RE: Amendment to the Dane County Water Quality Plan: Addition to the
Central Urban Service Area, Village of McFarland Portion

PROPOSED AMENDMENT TO THE
DANE COUNTY REGIONAL DEVELOPMENT GUIDE, FARM
PRESERVATION PLAN AND WATER QUALITY PLAN

1. Applicant: Village of McFarland
2. Title of Proposal: Amendment to the Central Urban Service Area
(McFarland portion)
3. Location: Dane County
Village of McFarland
Section 35, T7N, R10E and Section 2, T6N, R10E

ADDENDUM TO THE STAFF ANALYSIS
ON THE PROPOSED AMENDMENT TO THE CENTRAL URBAN SERVICE AREA
(McFARLAND PORTION)

McFarland Portion of the Central Urban Service Area

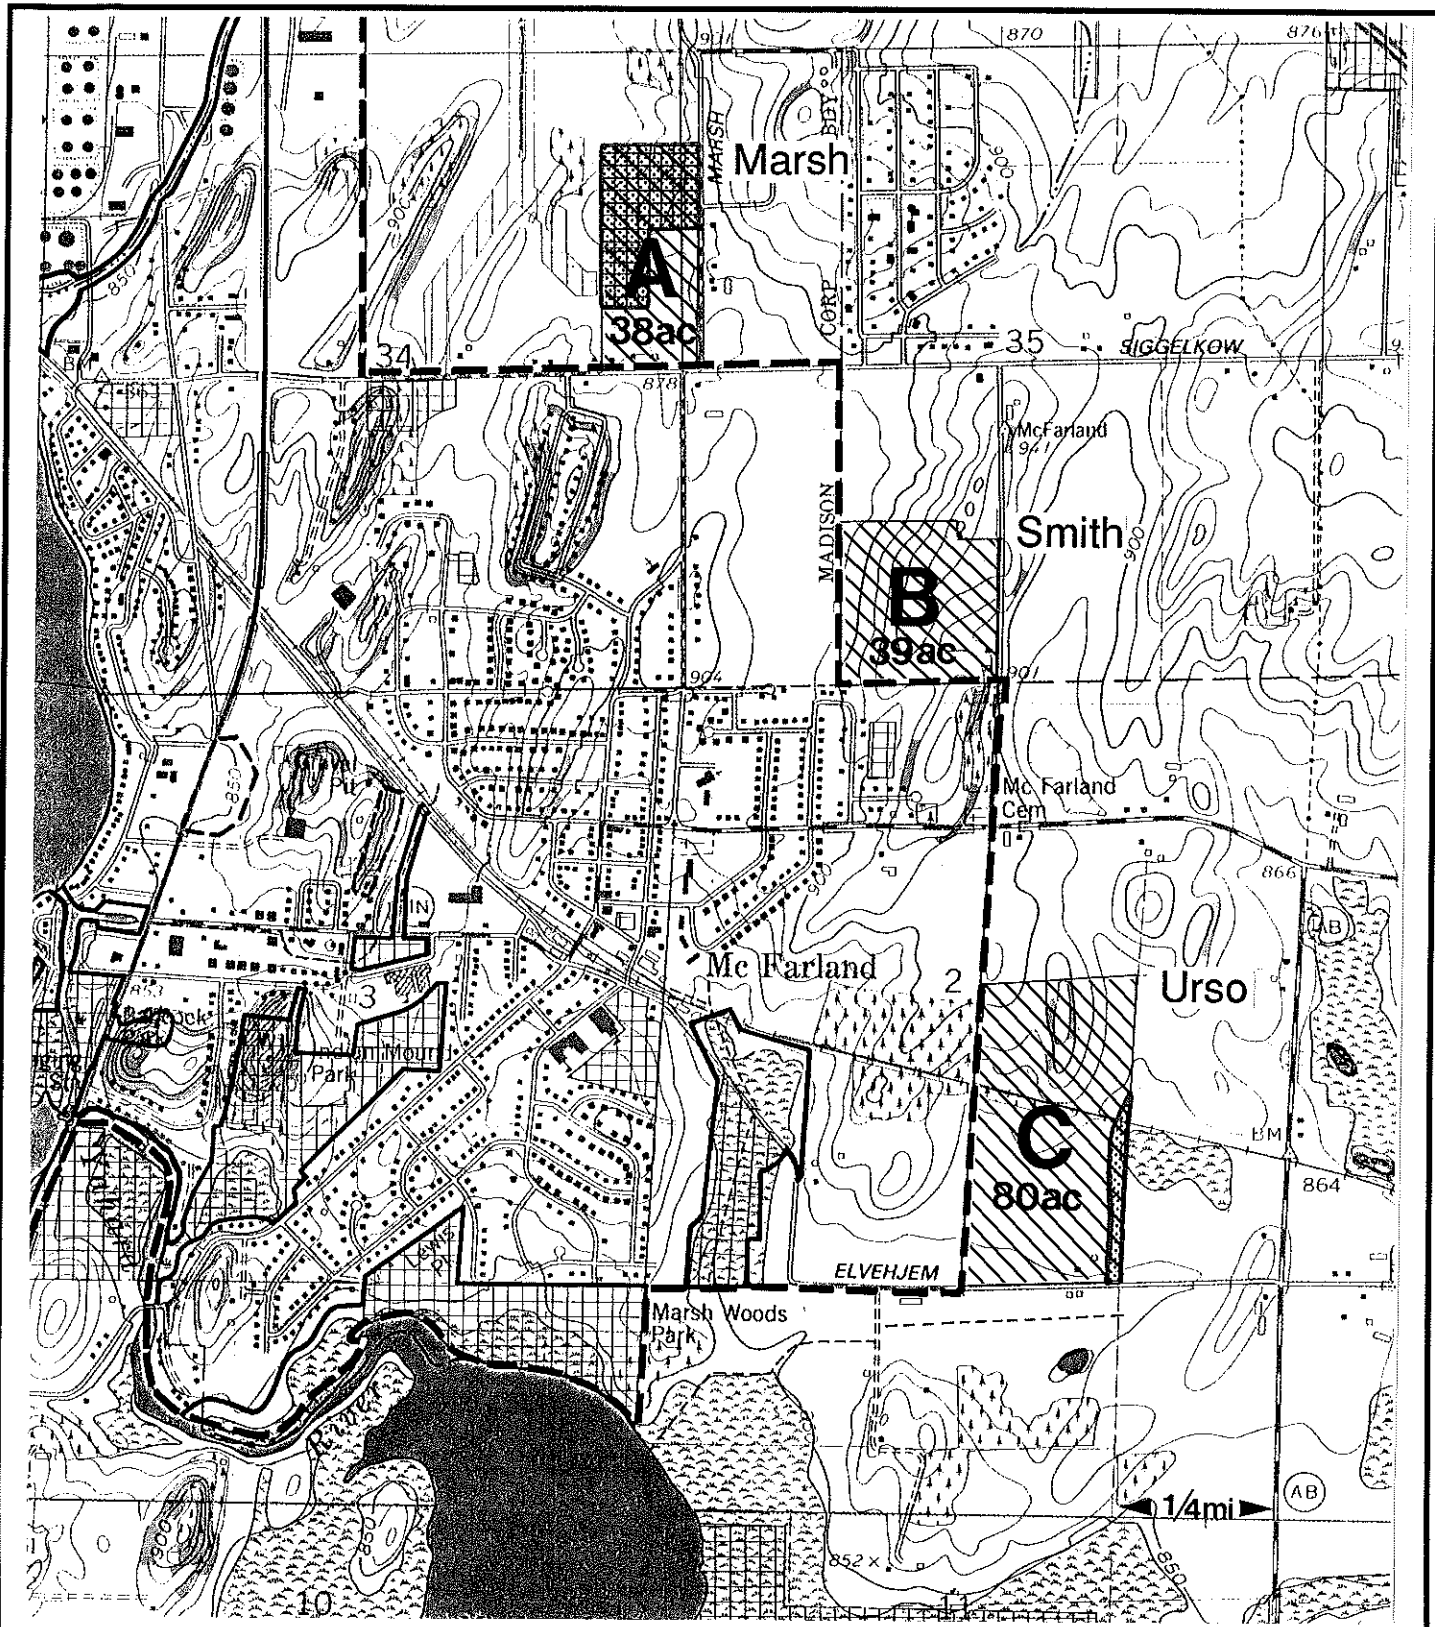
The staff of the Dane County Regional Planning Commission recommends approval of the request with adoption of the environmental corridors as depicted on the attached map, but that action should be postponed until map layouts of water, sewer and storm drainage systems (as required by the adopted CUSA requirements) are received from the village and reviewed.
